Building Code of Australia

Assessment Report

Project Address: 277 - 283 High Street, Maitland
Maitland Town Hall

Client: Maitland City Council
Report Number: 183885B
Revision: 03

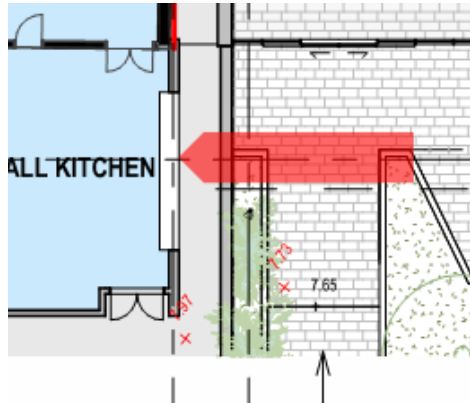
<p>Enclosure of space under stairs (D2.8)</p>	<p>The enclosing walls and ceilings of the enclosure under the main stairs are to have a FRL of at least 60/60/60 and the access doorway is to be fitted with a -/60/30, self-closing fire door or a performance solution is to be provided. Alternatively, the enclosing walls are to be removed.</p>  
<p>Goings and risers (D2.13) and landings (D2.14)</p>	<p>Treads to the main stairs are to be provided with a non-slip finish or nosing strip.</p>

<p>The width of the treads on the stairs leading to the stage do not comply with the prescribed minimum dimension of 250 mm (240 mm). The stairs are to be reconfigured or a performance solution to be provided.</p>
<p>Barriers to prevent falls (D2.16)</p>	<p>The height of the balustrade on the main stairs is to be upgraded to comply with the minimum height requirements of not less than 865mm above the nosings of the treads and not less than 1m along landings more than 500mm in length.</p>

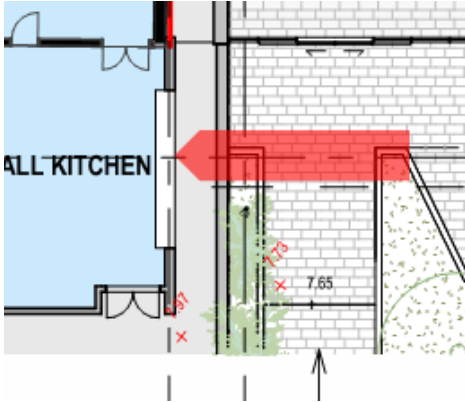
BCA Clause	Title	Assessment and Comment	Status
C1.9	Non-combustible building elements	<ol style="list-style-type: none"> 1. In a building required to be Type A or B construction, the following building elements and their components must be non-combustible: <ol style="list-style-type: none"> (a) External walls and common walls, including all components incorporated in them including the façade covering, framing and insulation. (b) The flooring and floor framing of lift pits. (c) Non-loadbearing internal walls required to be fire resisting. 2. A shaft, being a lift, ventilating, pipe, garbage, or similar shaft that is not for the discharge of hot products of combustion, that is non-loadbearing, must be of non-combustible construction in – <ol style="list-style-type: none"> (a) A building required to be Type B construction, subject to C2.10, in: <ol style="list-style-type: none"> (i) a Class 2, 3 or 9 building; and (ii) a Class 5, 6 or 8 building if the shaft connects more than 2 storeys. 3. A loadbearing internal wall and loadbearing fire wall, including those that are part of a loadbearing shaft, must comply with Specification C1.1. 4. The requirements of (1) and (2) do not apply to gaskets, caulking, sealants and dampproof courses. 5. The following materials may be used wherever a non-combustible material is required: <ol style="list-style-type: none"> (a) Plasterboard. (b) Perforated gypsum lath with a normal paper finish. (c) Fibrous-plaster sheet. (d) Fire-reinforced cement sheeting. (e) Pre-finished metal sheeting having a combustible surface finish not exceeding 1mm thickness and where the Spread-of-Flame Index of the product is not greater than 0. 	New works capable of complying
